INTERIOR GLAZING

SALEM GLASS COMPANY

PROJECT	KIRKLAND & ELLIS	PROJ NO	8901
ARCHITECT	HO&K	DATE	WORKING
GENERAL CONTRACTOR	STRUCTURE TONE, INC	DRAWN	SM
		CHECKED	SB/MO
		FILE NAME	8109 c 1
		SCALE	NO SCALE
		SHEET NUMBER	C102

3 ELEVATION—ELEVATOR LOBBY—NORTH & SOUTH
QUANTITY: 2
ARCH REF: 3/A803

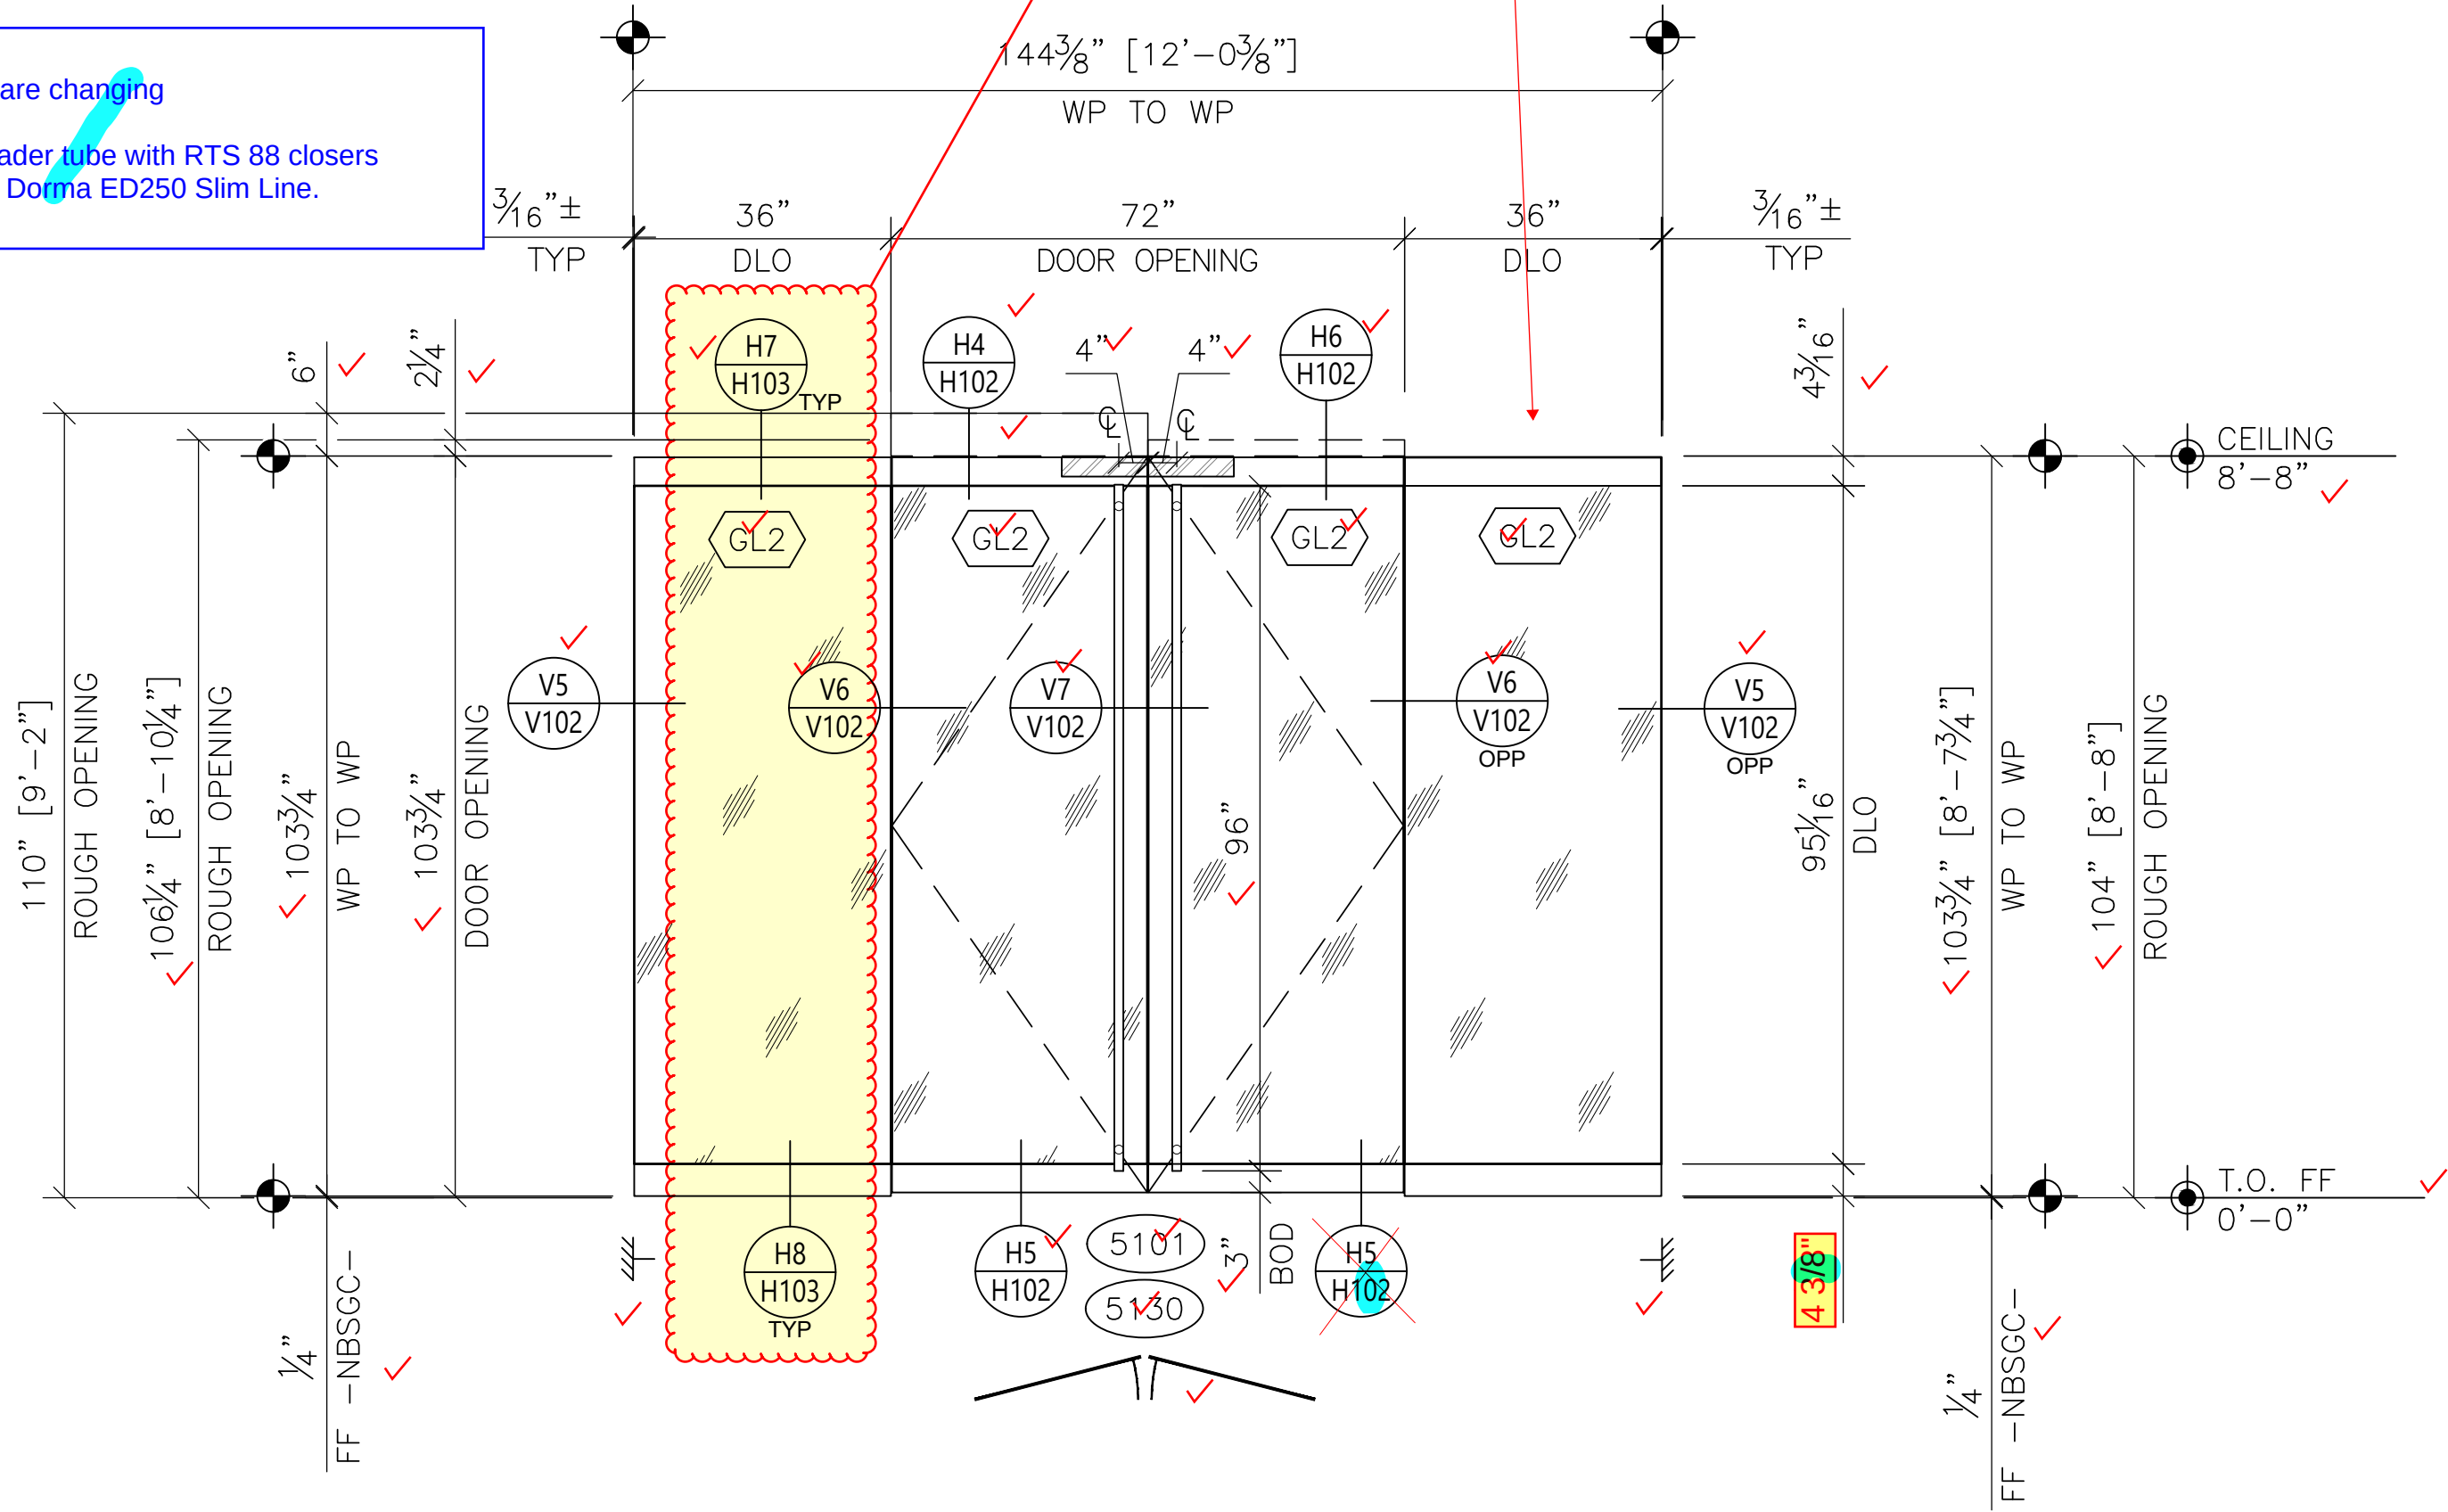
The ADOs are changing
Please show a standard header tube with RTS 88 closers
with a surface mounted Dornia ED250 Slim Line.

MAY I SUGGEST YOU MOVE THESE
H-DETAIL BALLS TO THE RIGHT
SIDELITE SO THEY ARE CLOSER
TO THE DIMS THAT MATCH THEM.

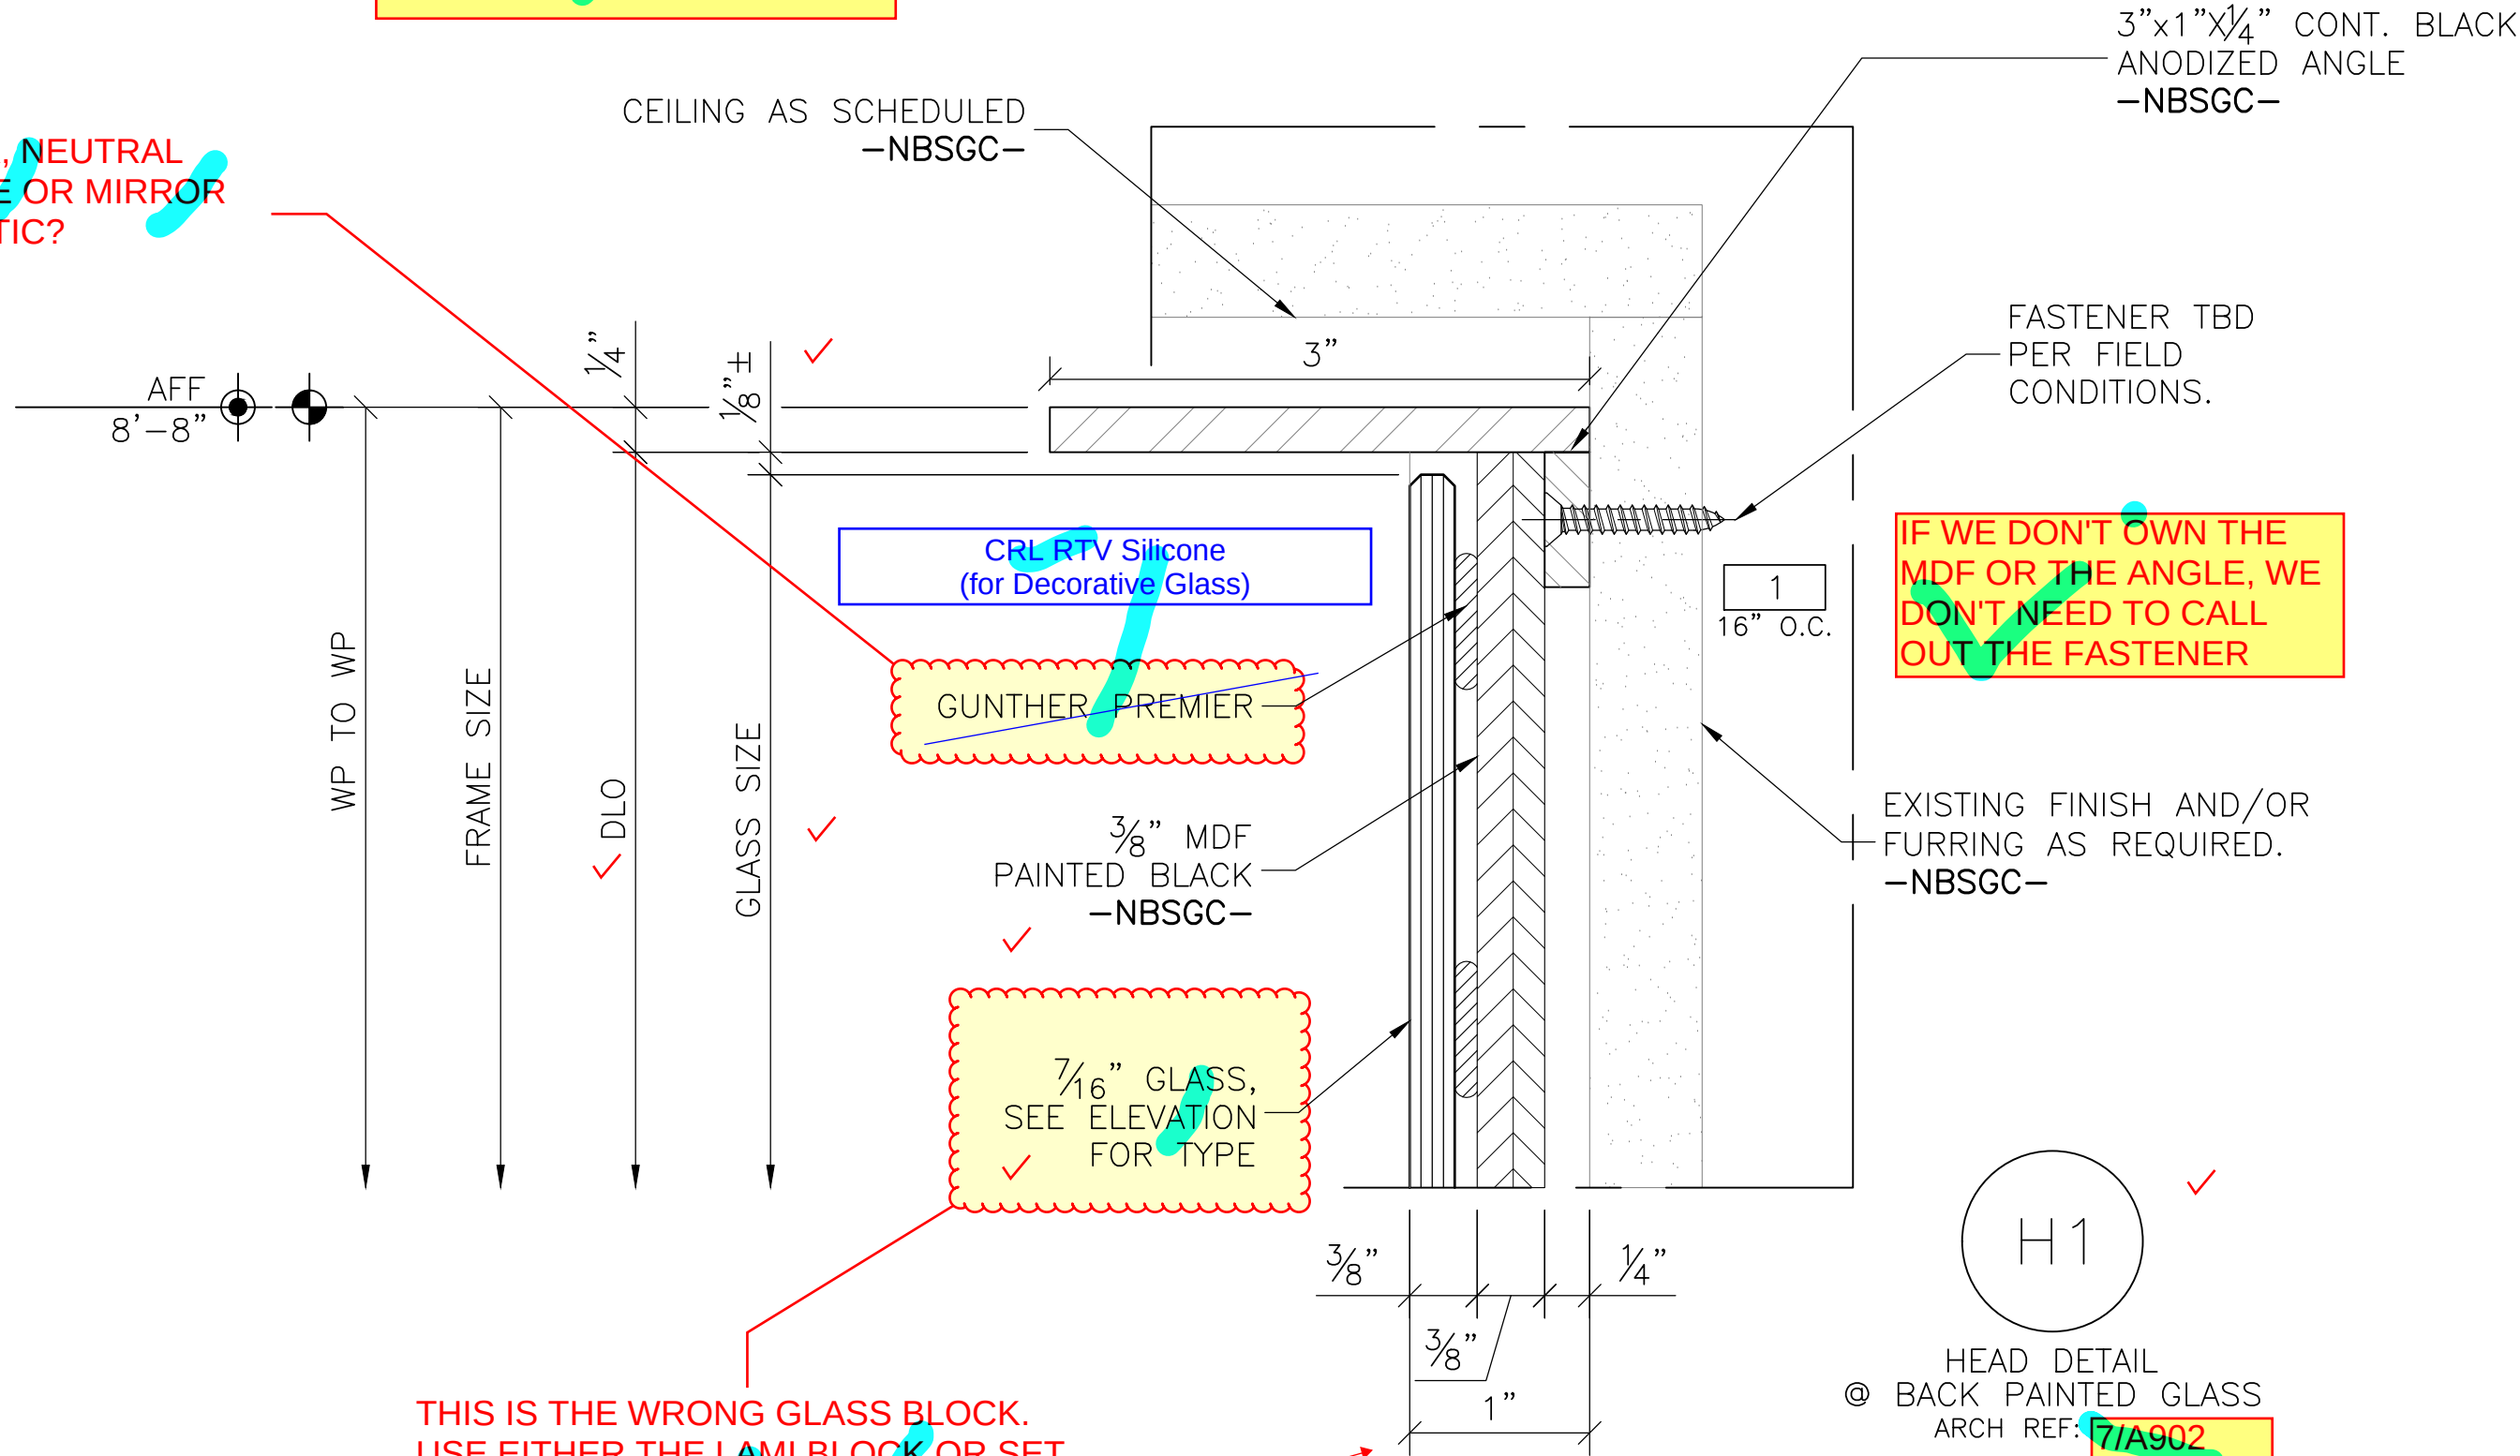
MICK, IS IT INTENTIONAL THAT THE DETAILS DO NOT MATCH THE ARCHS?

DETAIL DOES NOT MATCH ELEVATION

MICK, NEUTRAL CURE OR MIRROR MASTIC?

Yes, this is us controlling the narrative to a degree.

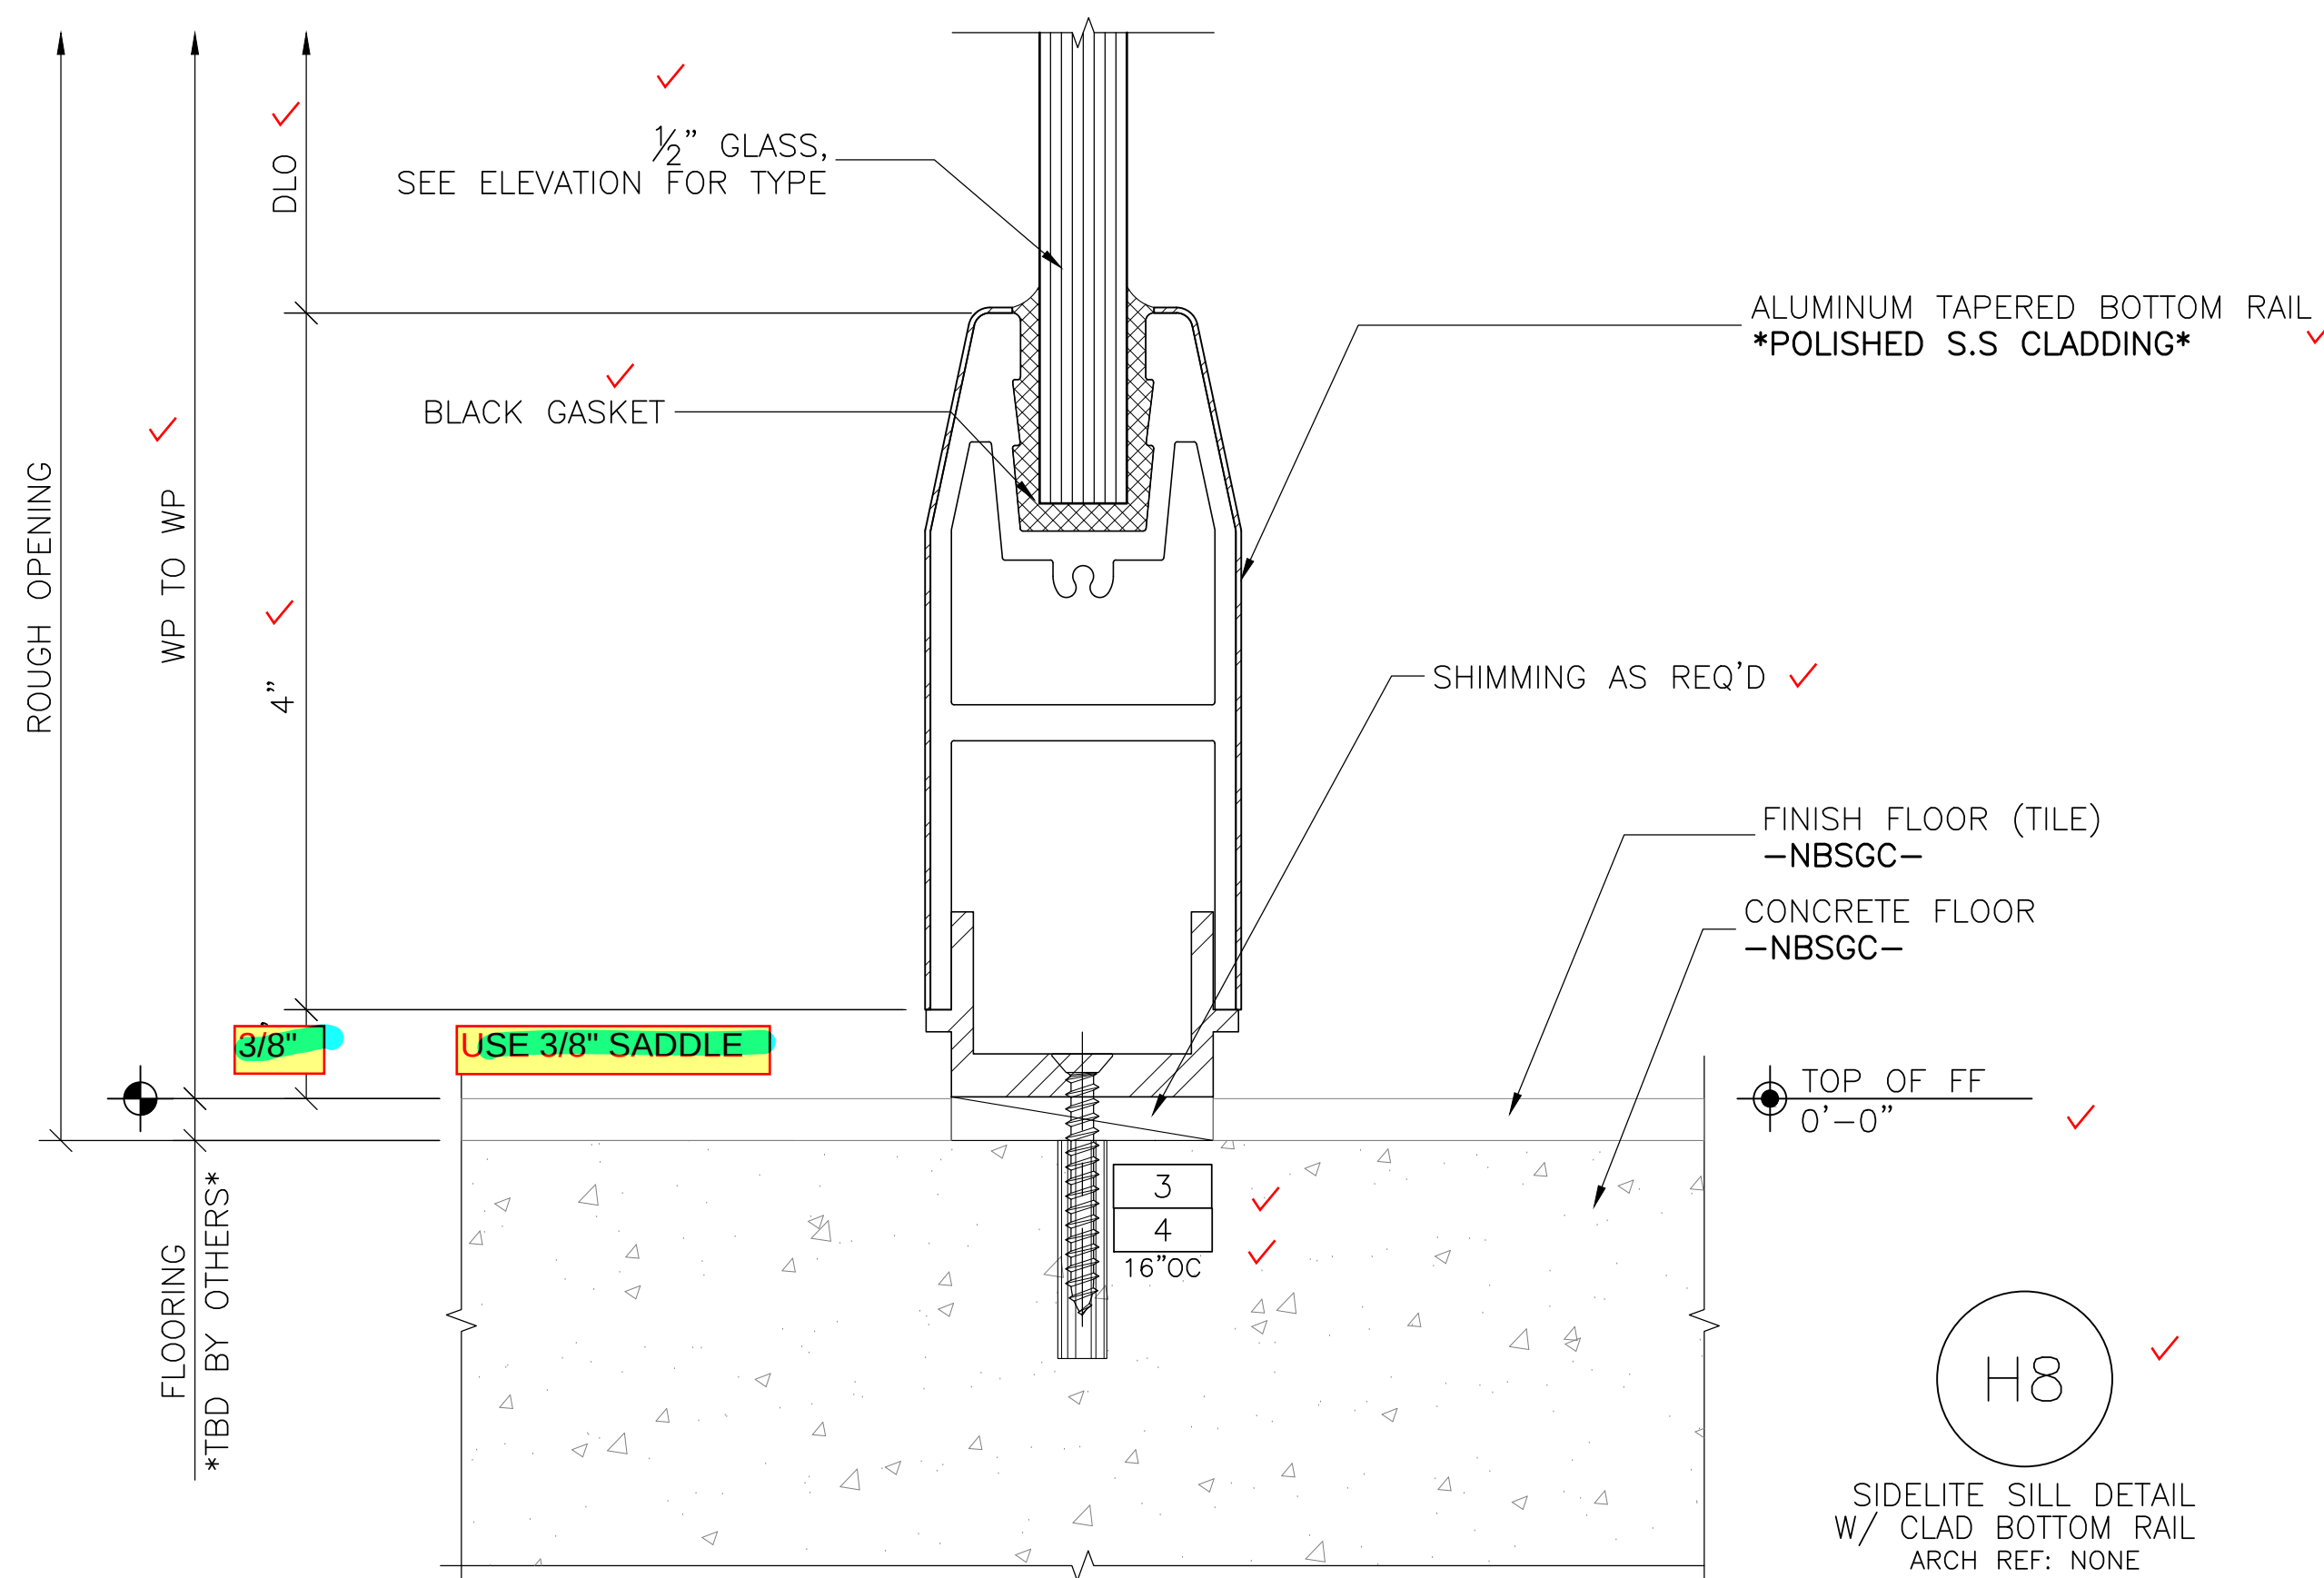
MICK, IS IT INTENTIONAL THAT THE DETAILS DO NOT MATCH THE ARCHS?

SEE NOTES FROM H-DETAILS
